COTTONWOOD HEIGHTS CITY ARCHITECTURAL REVIEW COMMISSION MEETING AGENDA

COTTONWOOD HEIGHTS CITY ARCHITECTURAL REVIEW COMMISSION STAFF REPORT

CUP-23-012

Certificate of Design Compliance
for Exterior Changes to Existing
Building

A1 NORTH ELEVATION
A201 3/16" = 1'-0"

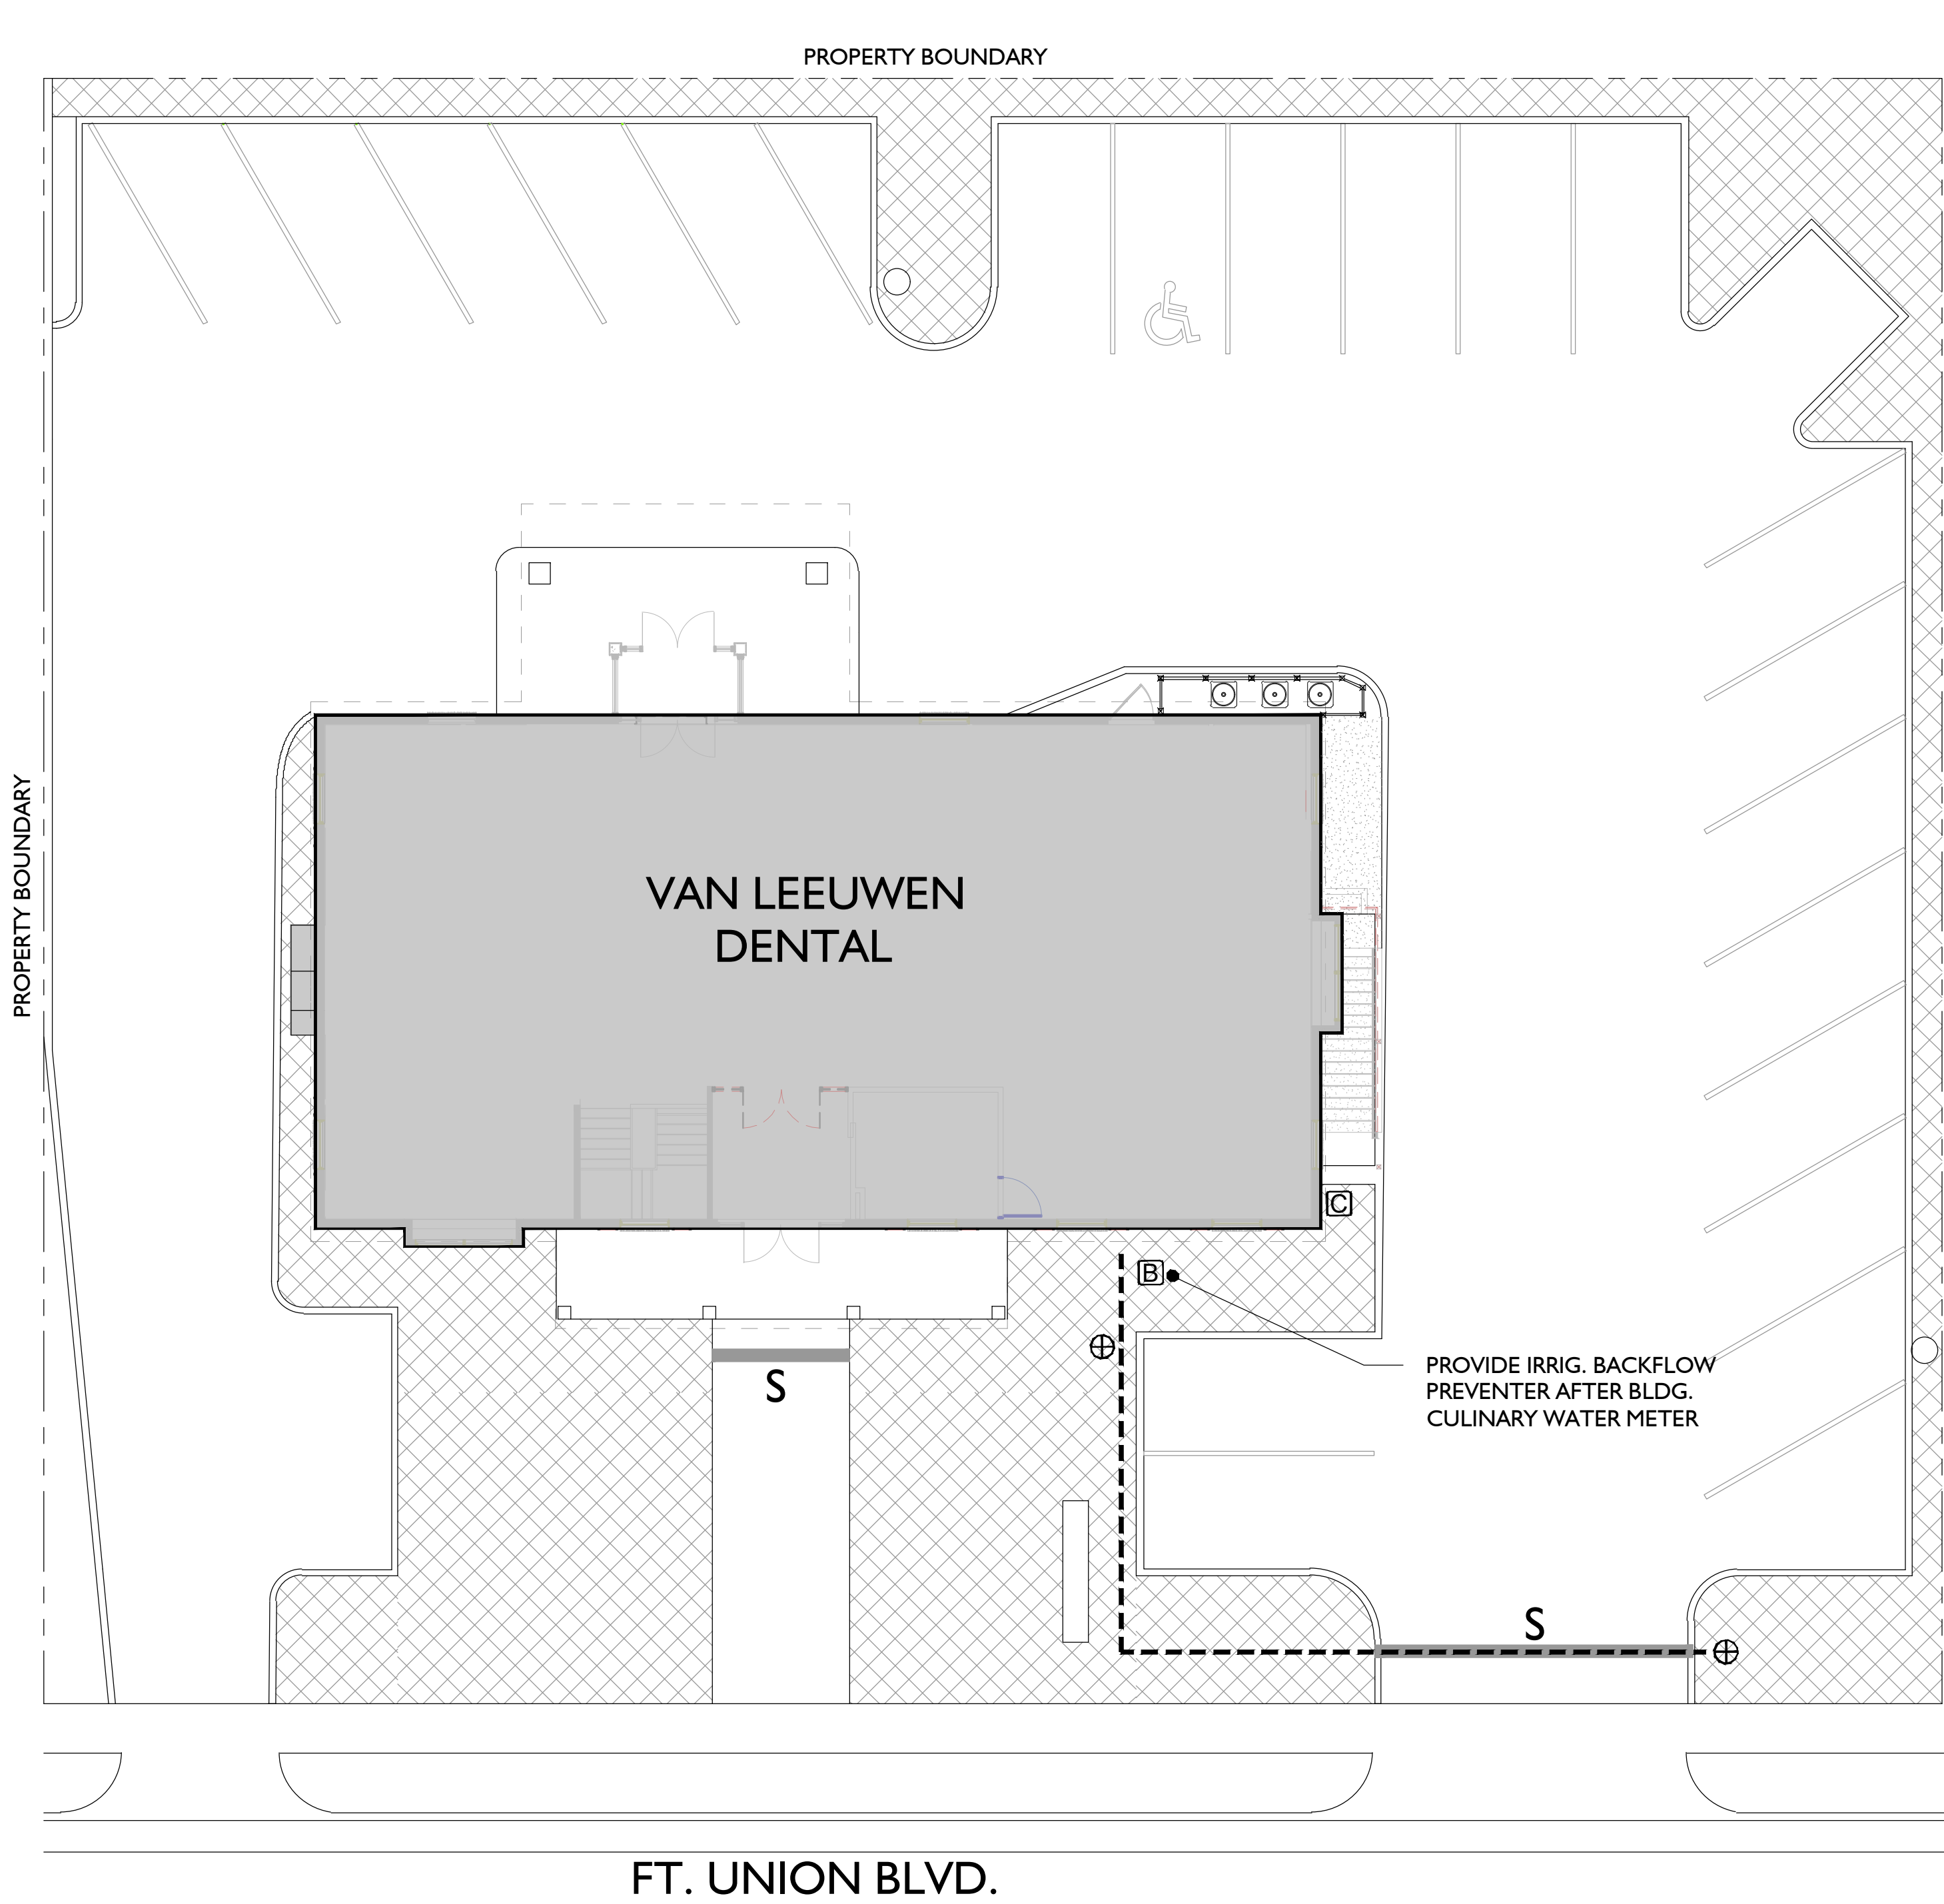
- **Requirement:** The majority of windows on a given floor should be relatively equal in size.
- **Project Compliance:** The additional window proposed on the north façade matches the building's existing windows.

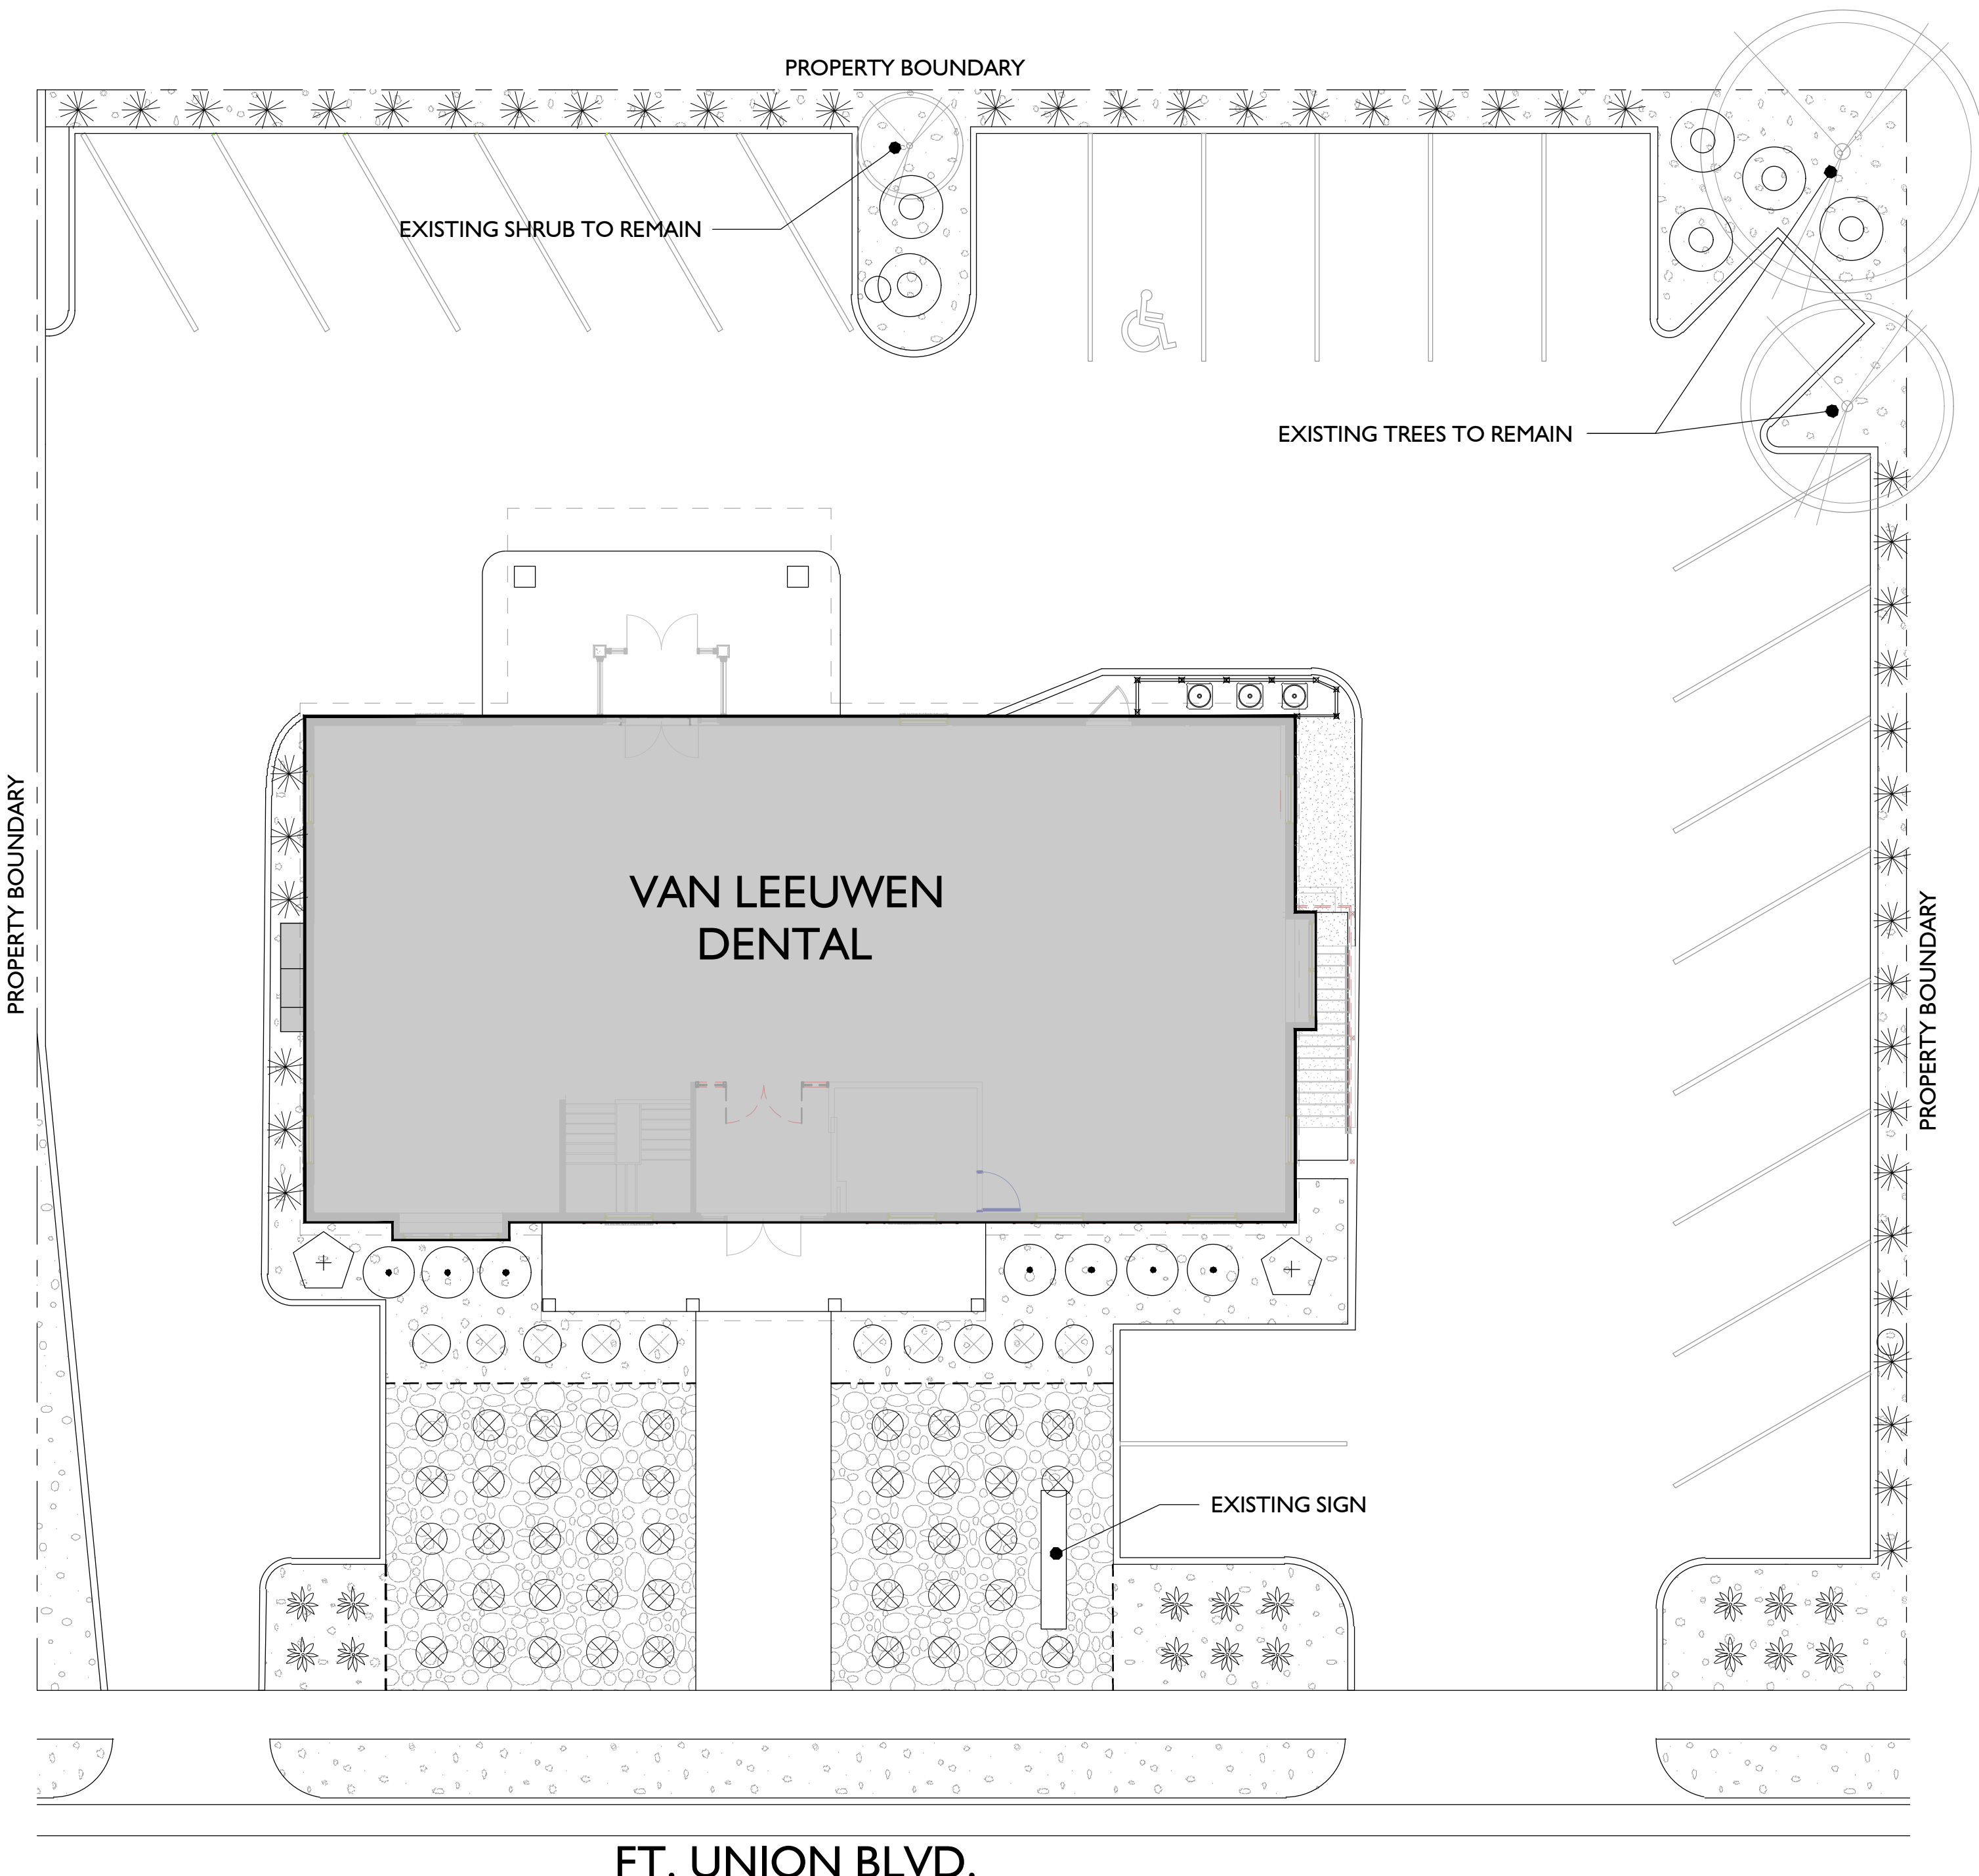
- **Requirements:** Landscaping should contribute to the overall appearance and function of the site as well as the streetscape. Developments in the Neighborhood Commercial Zone must provide a landscaped buffer between any residential properties.
- **Project Compliance:** The proposed landscaping preserves some existing foliage, as well as the existing landscaped buffer, while also providing new plantings which update the property with a high-quality aesthetic.
